Kapiti Coast District Council Section 42A Hearing Report under the Resource Management Act 1991 (RMA)

Application No.:	RM190125
Applicant:	Housing New Zealand Limited
Site Address:	35 Kaitawa Crescent, Paraparaumu
Legal Description:	LOT 62 DP 23300 CT B1/1459
Site Area:	842m ²
Applicant's Address for Service:	C/- WSP Opus PO Box 12 003 Thorndon, Wellington
Proposal:	To undertake a two lot residential subdivision that does not meet the shape factor, minimum and average lot sizes, requires consent for contaminants in soil and land use consent for the construction of two dwellings prior to the certification of the subdivision that do not meet the permitted activity standards for car parking, water demand management and accessory buildings encroaching the required yard setbacks
Operative District Plan Zone:	Residential
Proposed District Plan Zone:	Residential
Activity Status:	Subdivision - Non-Complying Land Use - Discretionary

Report prepared by: Marnie Rydon, Principal Resource Consents Planner
Report peer reviewed by: Eloise Carstens, Resource Consents Team Leader

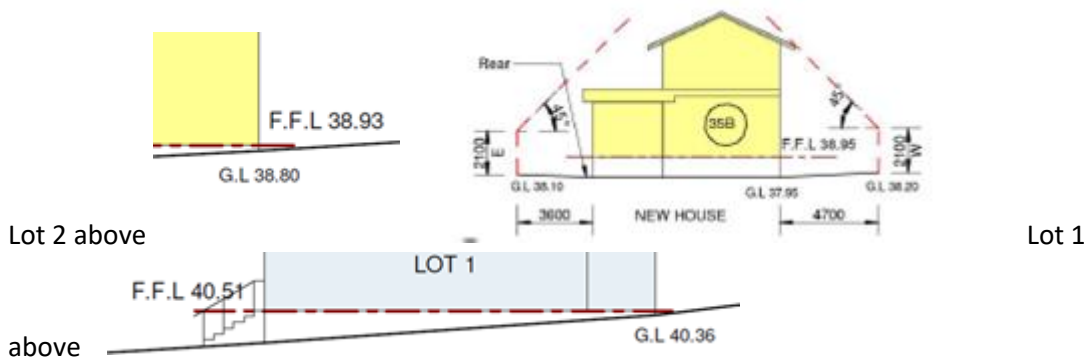
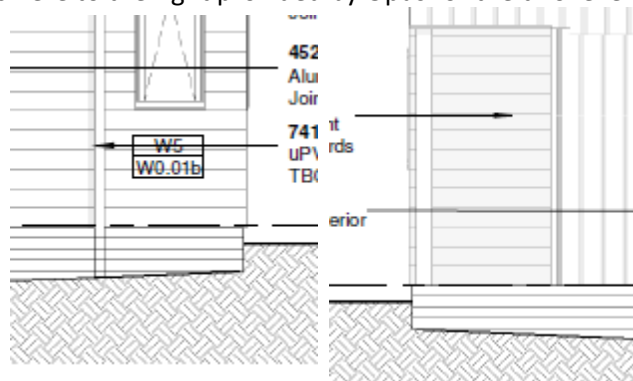
- The house is close to touching the day lighting angle and the foundations are shown with base boards.

- As per the building code, the underside of the floor joist to the ground level needs to be a minimum of 450mm. (175mm minimum to the bottom of the cladding) the information provided shows ground level to the finished floor at 130mm for lot2 and lot one at 150mm both non-compliant, if site cuts are to be carried out to drop the ground level this will need to be calculated and provided as part of the resource consent, this would need to include the sloping car part areas

- Both BC190722 & BC190676 provided by KDCDC are National Multiple-use approval establishes that the plans and specifications to which it relates comply with the building code. However they are designed for a flat site and don't take into consideration the sloping site at 35 Kaitawa Crescent, which has a 3.2mtr fall from the top boundary fence to the bottom fence hence my concerns mentioned above

- The details here to the right provided by Opus for the two level home are drawn being non-

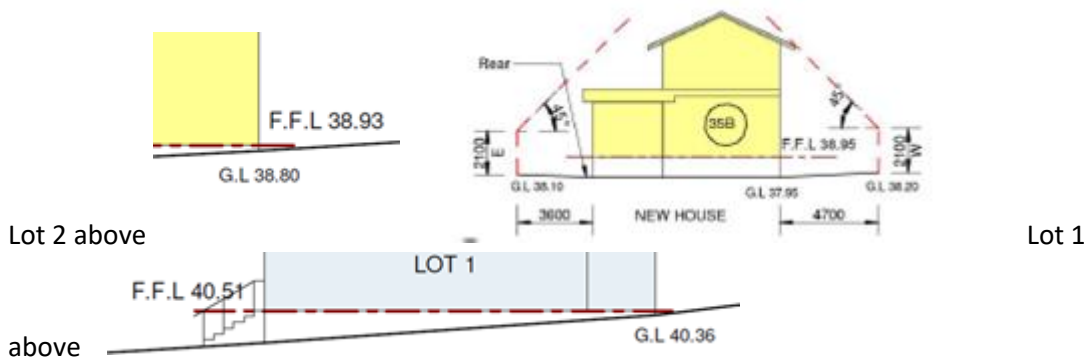
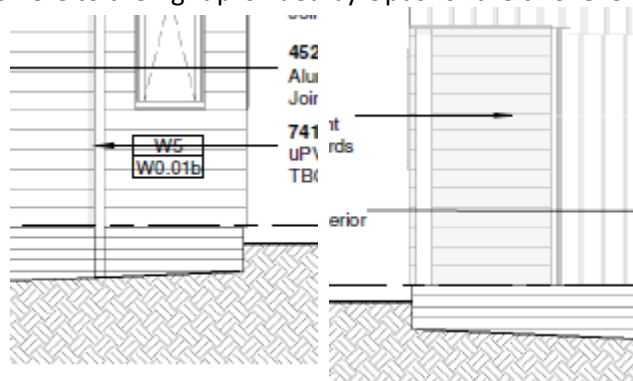
- The house is close to touching the day lighting angle and the foundations are shown with base boards.

- As per the building code, the underside of the floor joist to the ground level needs to be a minimum of 450mm. (175mm minimum to the bottom of the cladding) the information provided shows ground level to the finished floor at 130mm for lot2 and lot one at 150mm both non-compliant, if site cuts are to be carried out to drop the ground level this will need to be calculated and provided as part of the resource consent, this would need to include the sloping car part areas

- Both BC190722 & BC190676 provided by KCDC are National Multiple-use approval establishes that the plans and specifications to which it relates comply with the building code. However they are designed for a flat site and don't take into consideration the sloping site at 35 Kaitawa Crescent, which has a 3.2mtr fall from the top boundary fence to the bottom fence hence my concerns mentioned above

- The details here to the right provided by Opus for the two level home are drawn being non-

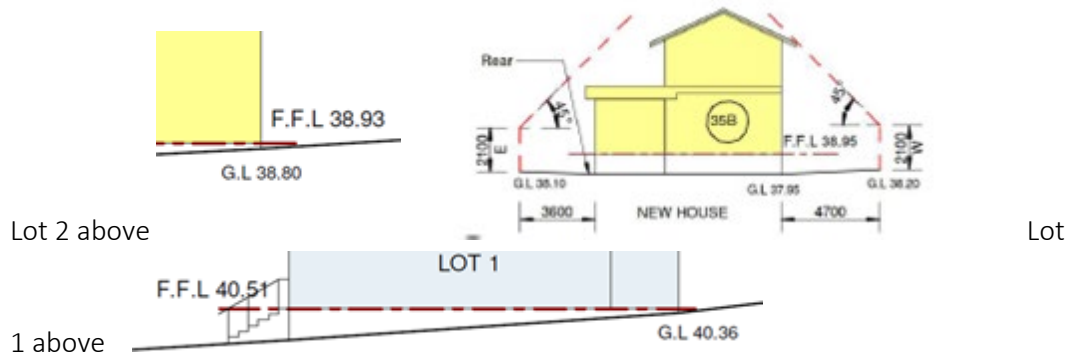
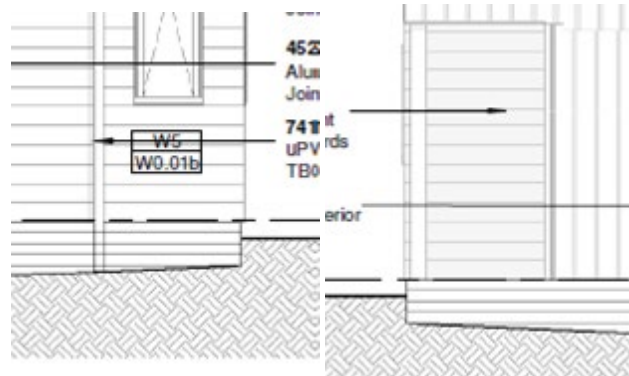
My concerns are around:

- The house is close to touching the day lighting angle and the foundations are shown with base boards.
- As per the building code, the underside of the floor joist to the ground level needs to be a minimum of 450mm. (175mm minimum to the bottom of the cladding) the information provided shows ground level to the finished floor at 130mm for lot2 and lot one at 150mm both non-compliant, if site cuts are to be carried out to drop the ground level this will need to be calculated and provided as part of the resource consent, this would need to include the sloping car park areas

- Both BC190722 & BC190676 provided by KCDC are National Multiple-use approval establishes that the plans and specifications to which it relates comply with the building code. However they are designed for a flat site and don't take into consideration the sloping site at 35 Kaitawa Crescent, which has a 3.2mtr fall from the top boundary fence to the bottom fence hence my concerns mentioned above

- The details here to the right provided by Opus for the two level home are drawn being

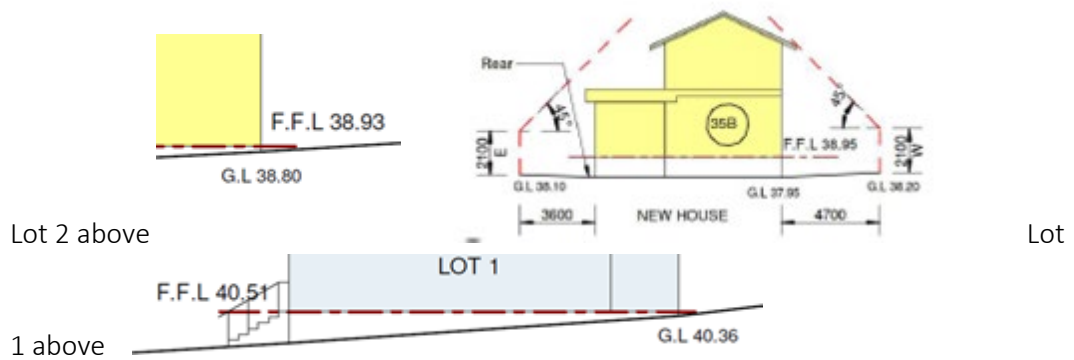
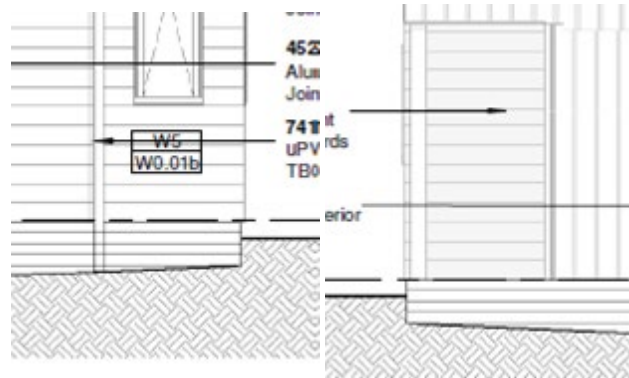
My concerns are around:

- The house is close to touching the day lighting angle and the foundations are shown with base boards.
- As per the building code, the underside of the floor joist to the ground level needs to be a minimum of 450mm. (175mm minimum to the bottom of the cladding) the information provided shows ground level to the finished floor at 130mm for lot2 and lot one at 150mm both non-compliant, if site cuts are to be carried out to drop the ground level this will need to be calculated and provided as part of the resource consent, this would need to include the sloping car part areas

- Both BC190722 provided by KCDC are National Multiple-use approval establishes that the plans and specifications to which it relates comply with the building code. However front lot is designed for a flat site and doesn't take into consideration the sloping site at 35 Kaitawa Crescent, which has a 3.2mtr fall from the top boundary fence to the bottom fence hence my concerns mentioned above

- The details here to the right provided by Opus for the two level home are drawn being

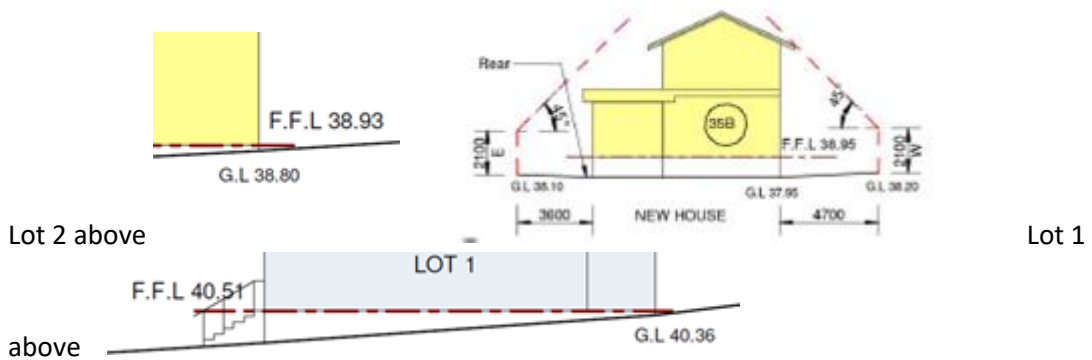
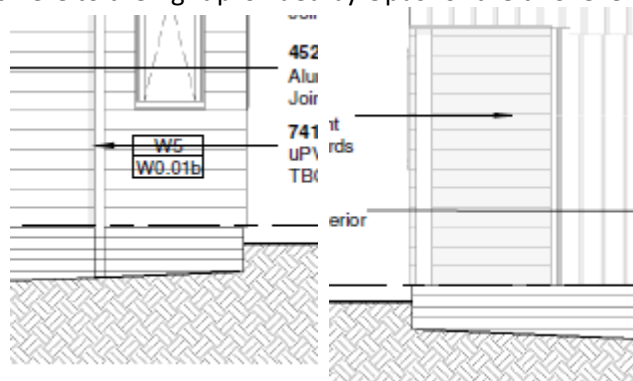
- The house is close to touching the day lighting angle and the foundations are shown with base boards.

- As per the building code, the underside of the floor joist to the ground level needs to be a minimum of 450mm. (175mm minimum to the bottom of the cladding) the information provided shows ground level to the finished floor at 130mm for lot2 and lot one at 150mm both non-compliant, if site cuts are to be carried out to drop the ground level this will need to be calculated and provided as part of the resource consent, this would need to include the sloping car part areas

- Both BC190722 & BC190676 provided by KCDC are National Multiple-use approval establishes that the plans and specifications to which it relates comply with the building code. However they are designed for a flat site and don't take into consideration the sloping site at 35 Kaitawa Crescent, which has a 3.2mtr fall from the top boundary fence to the bottom fence hence my concerns mentioned above

- The details here to the right provided by Opus for the two level home are drawn being non-

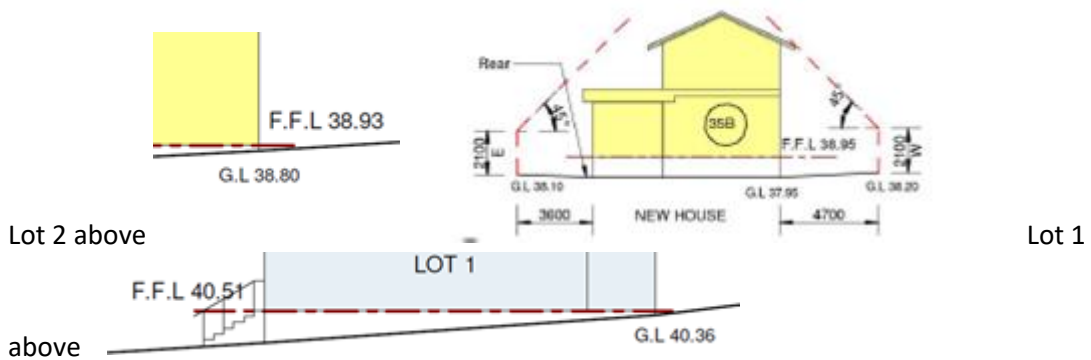
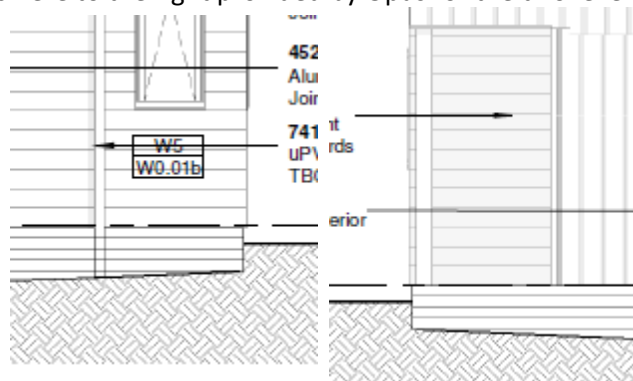
- The house is close to touching the day lighting angle and the foundations are shown with base boards.

- As per the building code, the underside of the floor joist to the ground level needs to be a minimum of 450mm. (175mm minimum to the bottom of the cladding) the information provided shows ground level to the finished floor at 130mm for lot2 and lot one at 150mm both non-compliant, if site cuts are to be carried out to drop the ground level this will need to be calculated and provided as part of the resource consent, this would need to include the sloping car part areas

- Both BC190722 & BC190676 provided by KCDC are National Multiple-use approval establishes that the plans and specifications to which it relates comply with the building code. However they are designed for a flat site and don't take into consideration the sloping site at 35 Kaitawa Crescent, which has a 3.2mtr fall from the top boundary fence to the bottom fence hence my concerns mentioned above

- The details here to the right provided by Opus for the two level home are drawn being non-
